# Desert Grove Retail Project (PLAN18-00049)

## Final Environmental Impact Report SCH No. 2018121029

**Desert Grove Retail Project**  
(PLAN18-00049)

**Appendix A:**  
**Revised TIA Exhibits and Analyses**

NO.	REVISIONS	BY	DATE																																									VICTORVILLE RETAIL PROJECT SWC US 395 & SR-18	
NO.	REVISIONS			BY	DATE																																												
<b>SITE PLAN</b>				<b>SP-01</b> SHEET NO. 1 OF 1

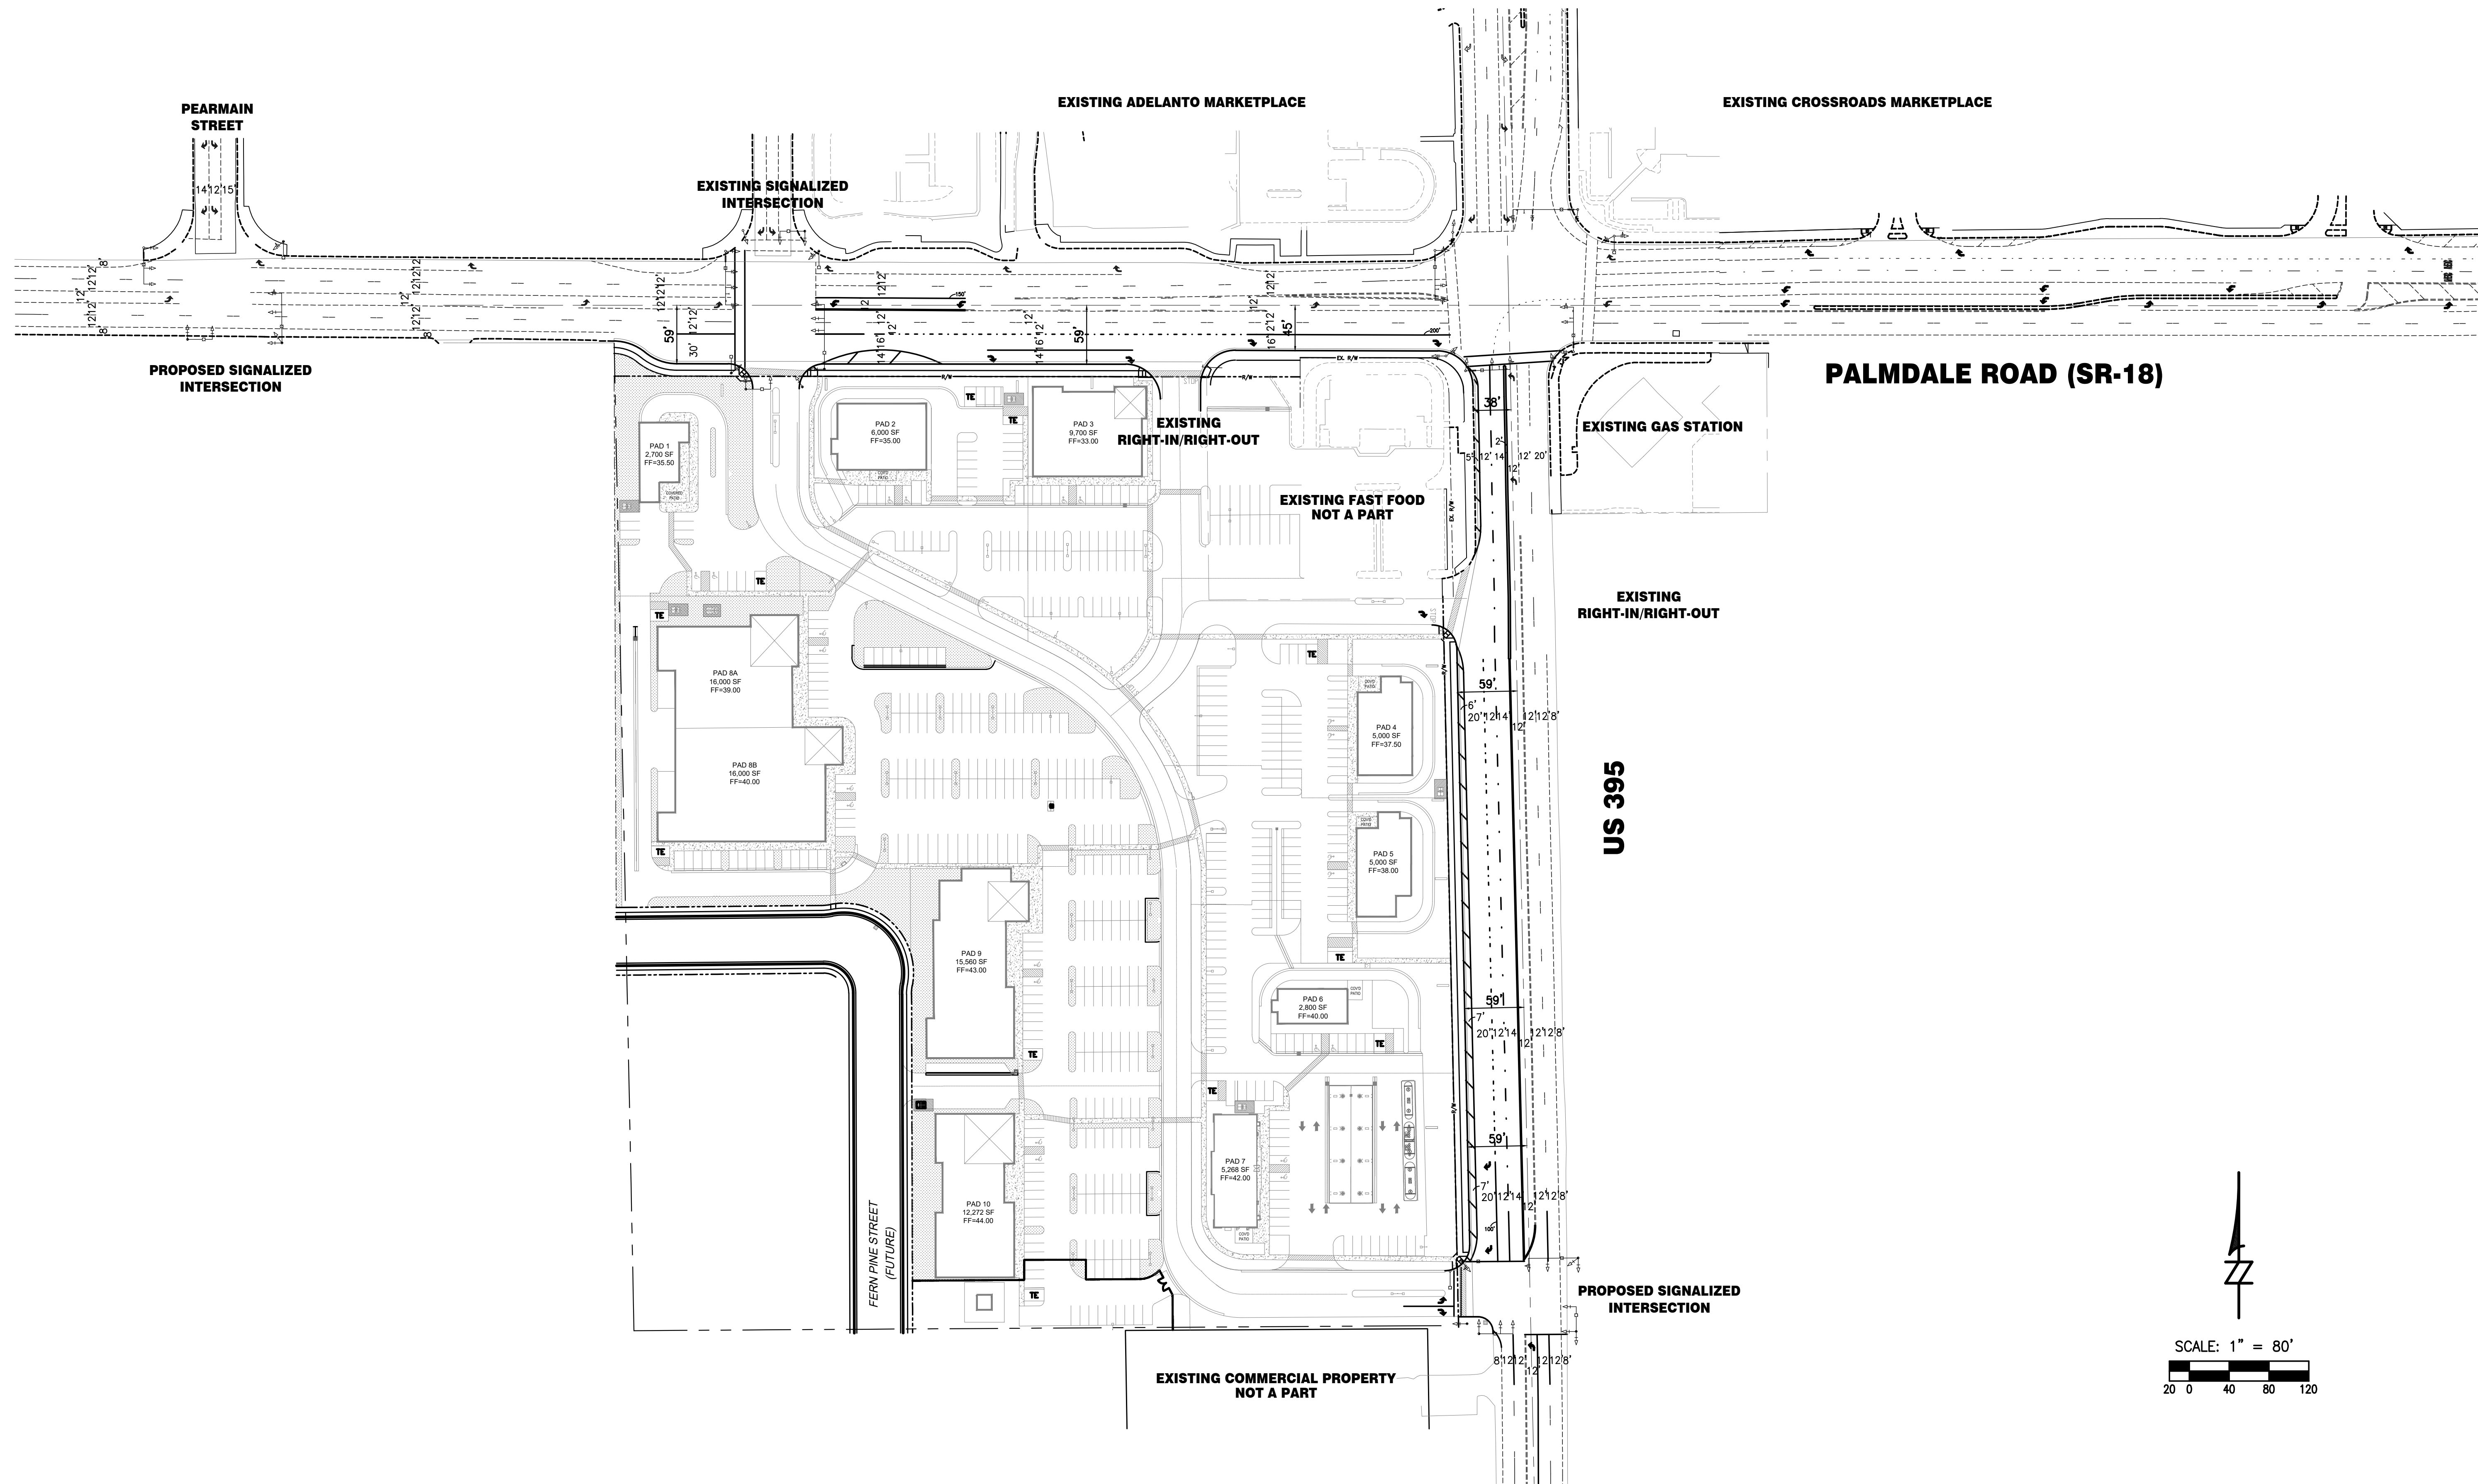
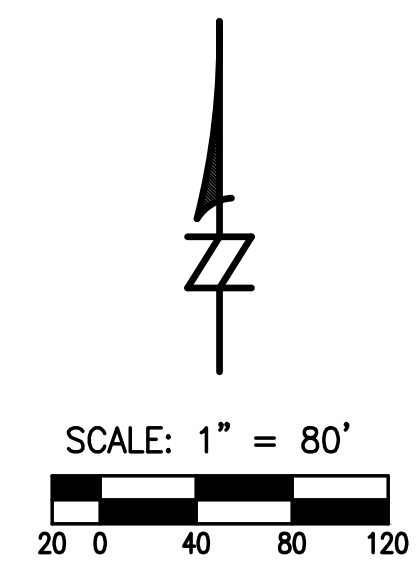
| 1. The proposed project site plan (Exhibit 1) is not legible and proposed accesses are not clear. Please clarify.  | DOT-3  |

1. *The proposed project site plan (Exhibit 1) is not legible and proposed accesses are not clear. Please clarify.*

Comment noted. The referenced TIA exhibit has been revised and is appended to this Final EIR at Appendix A.

5. *Provide the full site plan layout at State Route 18/U.S. Highway 395. The plan should cover all lane configurations from Pearmain Street to U.S. Highway 395 on State Route 18 and from State Route 18 to the proposed signalized access Driveway 3 on U.S. Highway 395 to verify that the proposed lane configurations matches with the TIA. The plan should show all proposed access driveways, existing and proposed striping, existing and proposed right of way, storage lengths, bike lanes, sidewalks, and roadway dimensions. A detailed review will be done during the Encroachment Permit Process.*

Comment noted. The referenced TIA exhibits have been revised and are appended to this Final EIR at Appendix A.

## Exhibit 2: Project Location and Study Area

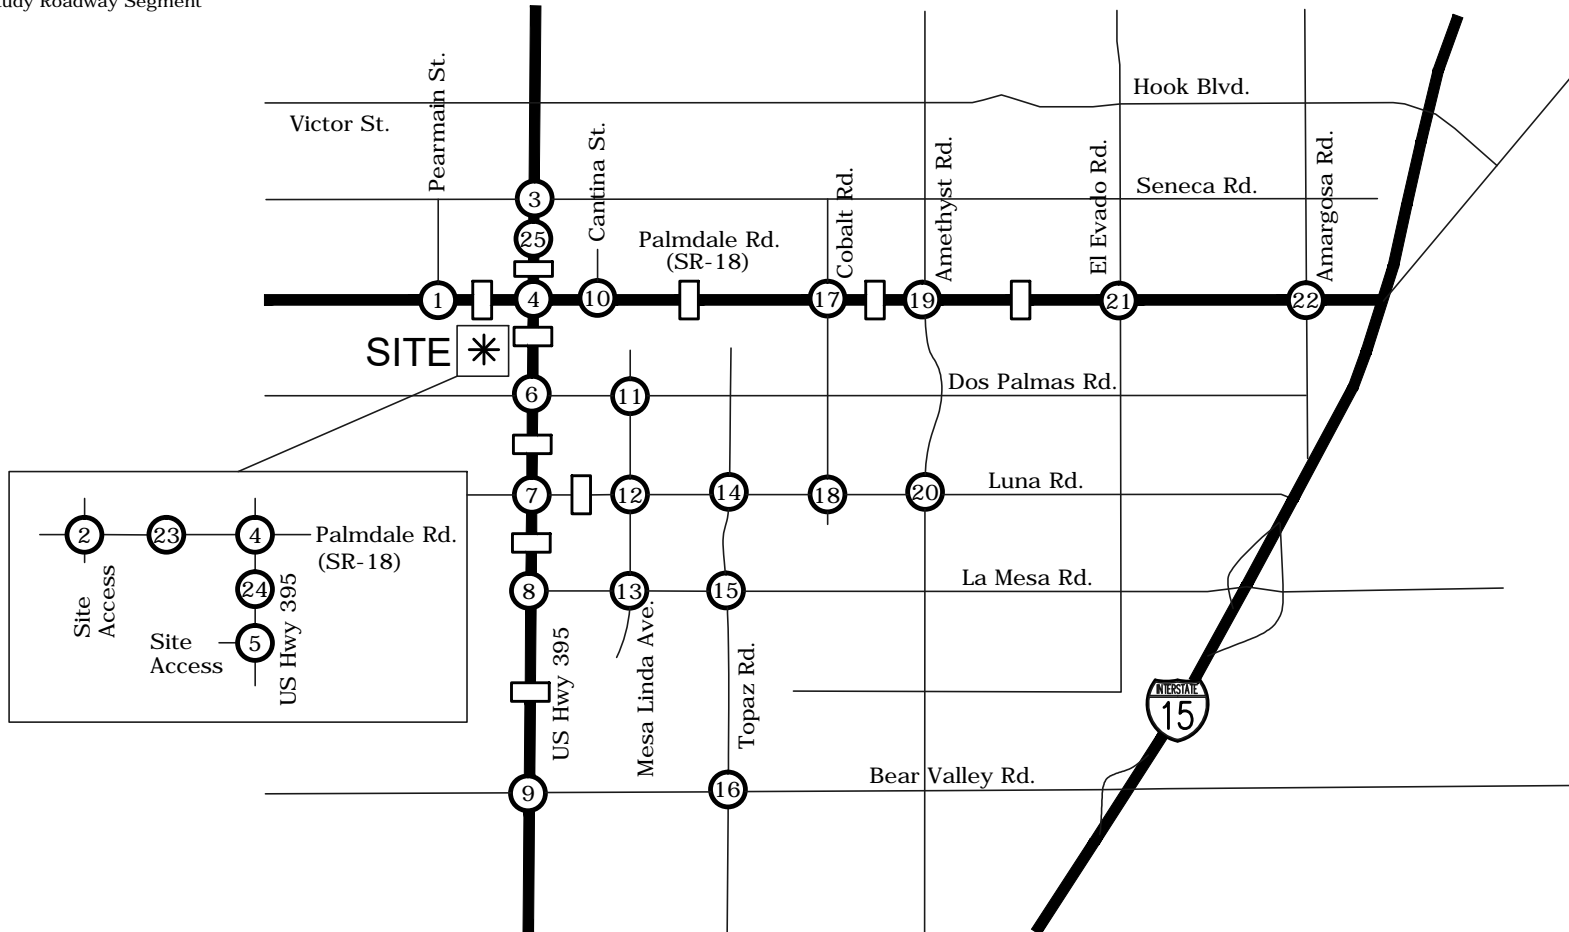
6. *All the intersections' numbers of proposed driveways need to be indicated correctly in all exhibits and site plans.*

Comment noted. The referenced TIA exhibits have been revised and are appended to this Final EIR at Appendix A.
